*2013 Integrated Energy Policy  
Report*

Docket No. 13-IEP-IE

RE: Transmission Planning and  
Permitting Issues

**Joint Comments of the California Consumers Alliance and the Clean  
Coalition regarding the Workshop on California and Western States  
Transmission Planning and Permitting Issues**

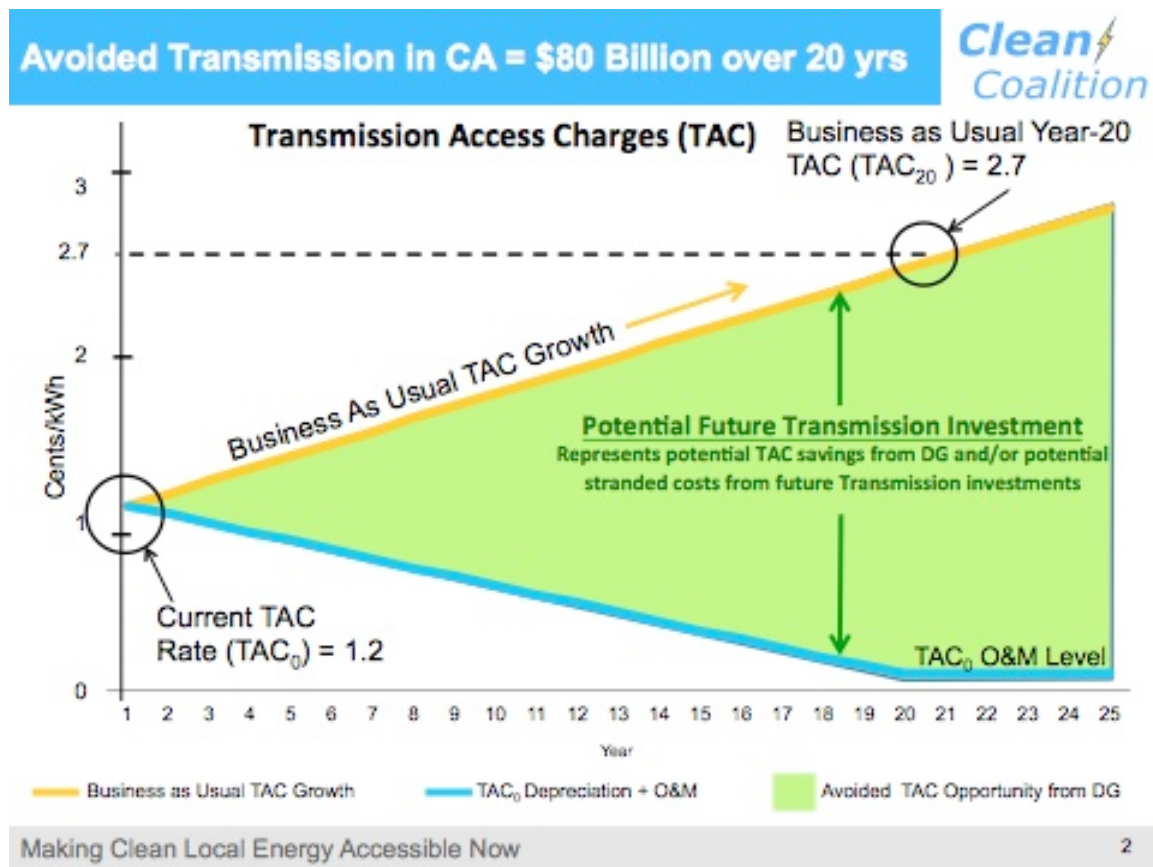
Slide 14 of Neil Millar's Transmission Planning to Support 33% RPS presentation indicates that the 230 kV Gregg-Gates line has policy or economic benefits.

III. What alternatives did the CAISO consider when it found the 230 kV Gregg-Gates line had policy or economic benefits?

IV. Specifically, did the CAISO consider alternatives such as; (a) tripping generation and/or pump load under contingency conditions; (b) supplying flexibility services from other Balancing Authorities through dynamic schedules; (c) Supplying flexibility services through new dispatchable generation that has to be added in the southern California Local Capacity Requirement (LCR) areas, etc?

V. How did the alternatives compare economically to the 230 kV Gregg-Gates project?

VI. Where can stakeholders find a description of the CAISO's economic analysis?

*The ISO's study of the Central California area followed the study plan presented for stakeholder input and found on our website at [http://www.caiso.com/Documents/CentralCalifornia\\_StudyScope.pdf](http://www.caiso.com/Documents/CentralCalifornia_StudyScope.pdf). The study tested all aspects of value investigated in the ISO planning process (reliability benefits, policy benefits and economic benefits) and tested against the cost and performance of the various alternatives. Alternatives are discussed in the study results, which are provided in section 3 of the 2012/2013 Transmission Plan found at: <http://www.caiso.com/Documents/BoardApproved2012-2013TransmissionPlan.pdf>.*

*The reference on Slide 14 to determining that the line had policy or economic benefits is specifically in the context of determining whether the project would be assigned to an incumbent participating transmission owner or be eligible for the ISO's competitive solicitation process. Reliability projects that do not provide other policy or economic benefits are currently assigned to incumbent participating transmission owners, and projects that do meet the FERC-approved tariff criteria are eligible for competitive solicitation.*

*I note that as set out on page 146, Section 3 of the ISO's 2012/2013 transmission plan, "the assessment utilizes similar water usage as historical operation of HELMS and does not reflect additional utilization that may be required for renewable integration and flexibility requirements." To summarize, the analysis considered preserving the value the HELMS presently provides through services provided today, and conservatively did not seek to attribute additional value to the role the resource may play in providing flexibility services in integrating renewable generation in the future.*
